Office Action Summary	Application No. 10/580,138	Applicant(s) DANERI ET AL.	
	Examiner Carl D. Price	Art Unit 3749

DETAILED ACTION

U.S. Patent May 25, 1976 Sheet 1 of 2 3,958,413

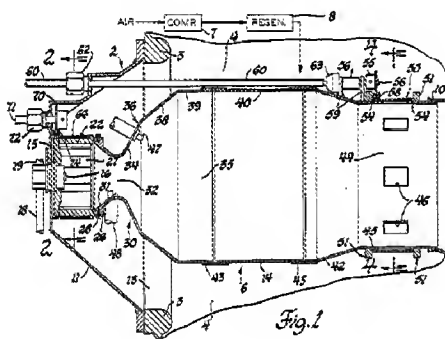
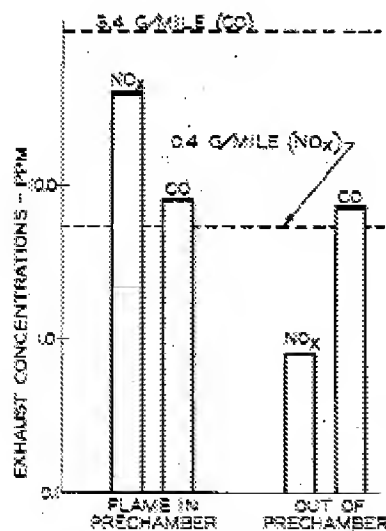
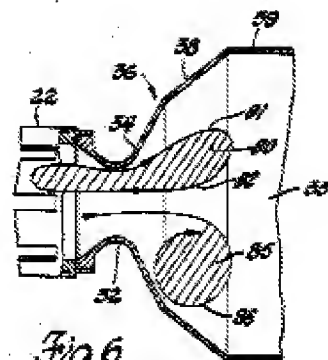
US 3958413 (Cornelius et al) teaches, from applicant's same multi-mode flame and flameless burner field of endeavor, means introducing pre-heated air and wherein when operating on the gas regulation system, it is possible to continuously switch from a flame functioning mode of the burner to a flameless functioning mode (i. e. - "invisible burning"), the latter characterized by low emissions of polluting agents.

(23) **When the flame** has been established and is **fully expelled from the prechamber,** there is substantially **invisible burning** in the **reaction chamber recirculation zone 85** of the previously formed mixture of vaporized fuel and air. This is attended by extremely low emissions of carbon monoxide and nitrogen oxides, as well as unburned hydrocarbons and smoke, which are much less a problem than are carbon monoxide and nitrogen oxides. (Highlighting and Underlining Added)

(24) **FIG. 5 illustrates the magnitude of the reduction in the emissions of nitrogen oxides** that can be obtained when the flame is forced out of the prechamber while using the combustion apparatus shown in FIGS. 1 through 4 and operated as described above. Note that the vertical scale is a logarithmic scale of nitrogen oxide and carbon monoxide concentrations in parts per million. Concentration data are shown for a typical stabilized combustor operating condition where the flame is either in or out of the prechamber. The broken line identified as 3.4 g/mile (CO) represents the maximum allowable carbon monoxide content, assuming a vehicle fuel consumption of ten miles per gallon. The broken line identified as 0.4 g/mile (NO.sub.x) represents the allowable production of nitrogen oxides, assuming the same fuel consumption. (Highlighting and Underlining Added)

US 5570679 (Wunning) shows:

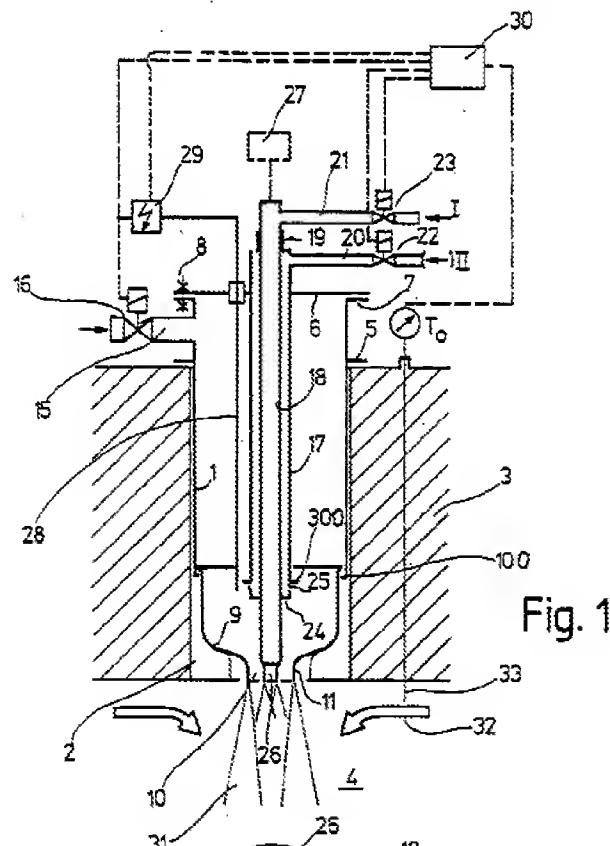
US 5570679 (Wunning) teaches, from applicant's same multi-mode flame and flameless burner field of endeavor, teaches, from applicant's same multi-mode flame and flameless burner field of endeavor, means introducing pre-heated air (15) and wherein when operating on the gas regulation system (22, 23, 30), it is possible to continuously switch from a flame functioning mode of the burner to a flameless functioning mode (i. e. - "an essentially flame-- and pulsation-free reaction"), the latter characterized by low emissions of polluting agents.

(4) A **lateral air supply stub 15** is connected to the jacket tube 1 outside the furnace wall 3; a combustion air valve 16 is located in this stub 15, and **optionally preheated combustion air** can be supplied by way of the stub 15. The combustion air supply stub 15, together with the jacket tube 1 and the combustion air valve 16, forms the air supply device, which as seen from the drawing is shaped such that all the combustion air supplied acts upon the combustion chamber 9 and emerges from the outlet opening 10 thereof. (Highlighting and Underlining Added)

(15) As soon as the **furnace chamber 4 has been heated to the ignition temperature of the fuel** assigned to the outer fuel lance 17, which is ascertained by a temperature sensor 33 protruding into the furnace chamber 4, **the control unit 30 switches the burner over to a second operating state**; to do so, it closes the first fuel valve 22 and opens the second fuel valve 23. **This switchover may be done in stages or continuously.** (Highlighting and Underlining Added)

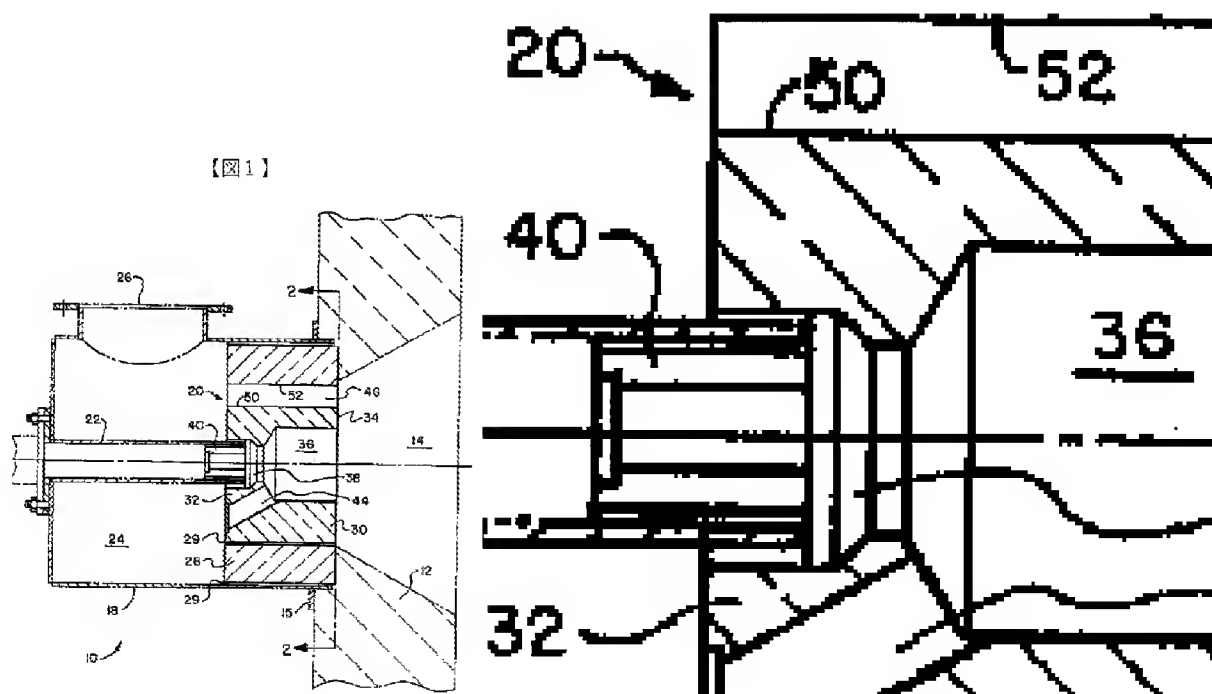
JP 07-190319 teaches, from applicant same central lance type burner field of endeavor, shows a refractory unit (20) with a free annular crown (i.e. – the free space about the distal end of lance) and being defined between the inner surface of said central hole (generally 38) and the external diameter of said tip portion (the distal end located within the refractory body recess) of the inner central lance, said free annular crown being in communication with said plenum (24) thereby allowing the passage of a sufficient quantity of air there around, which would necessarily act to cool the tip of inner central lance.

Fig. 9

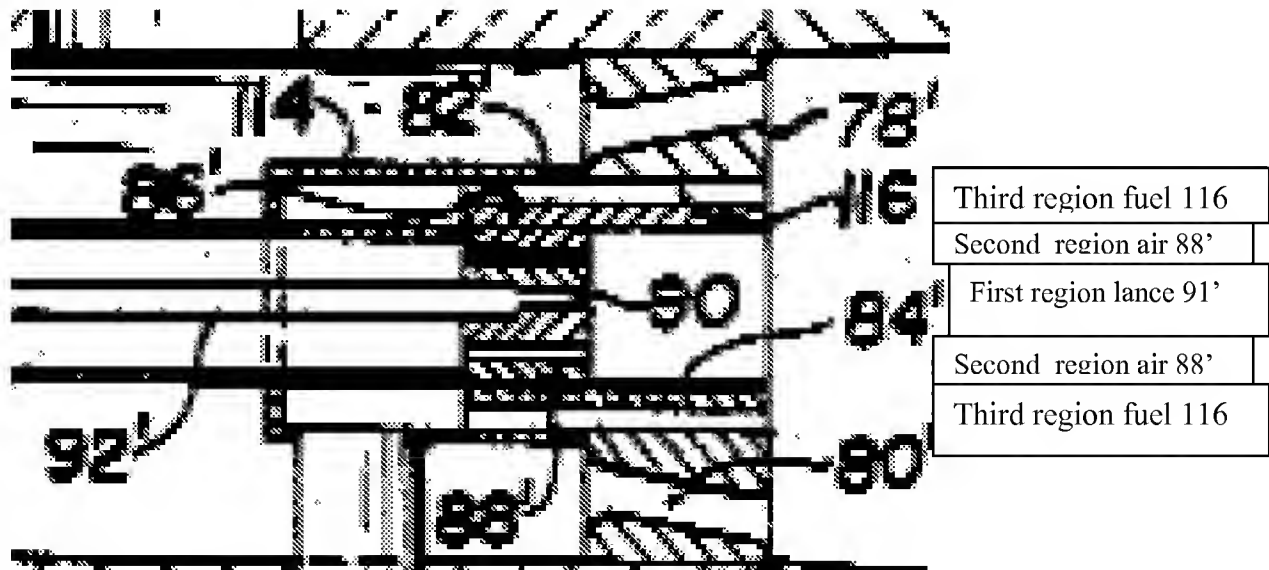
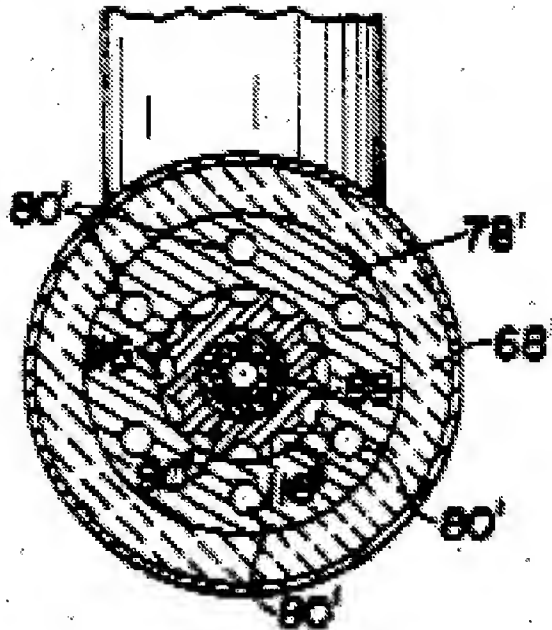
In regard to **claim 3**, **US 3418062 (Hovis et al)** shows (see the annotated figures herein below) nozzles (88') for the air housed in the second region.

In regard to **claim 5**, **US 3418062 (Hovis et al)** shows the first region comprising a cavity (84') communicating with the combustion chamber (76') and into which the air from the series of calibrated holes (88') flows together with the combustible gas injected through the inner lance.

In regard to **claims 7, 8 and 10**, **US 3418062 (Hovis et al)** shows the nozzles of said series of nozzles situated at an equal distance along a coaxial circumference with the inner lance (90', 92') and lying on a base surface of the second region (see the annotated figures herein below).

Fig. 11

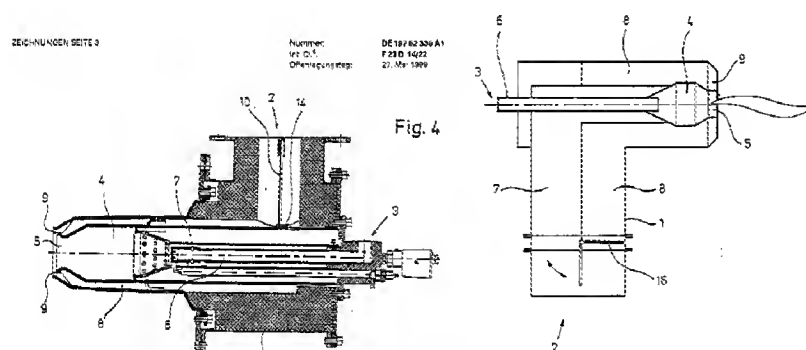
See **DE 19752335 A1** which discloses air-inlet (2) for pre-heatable combustion air:
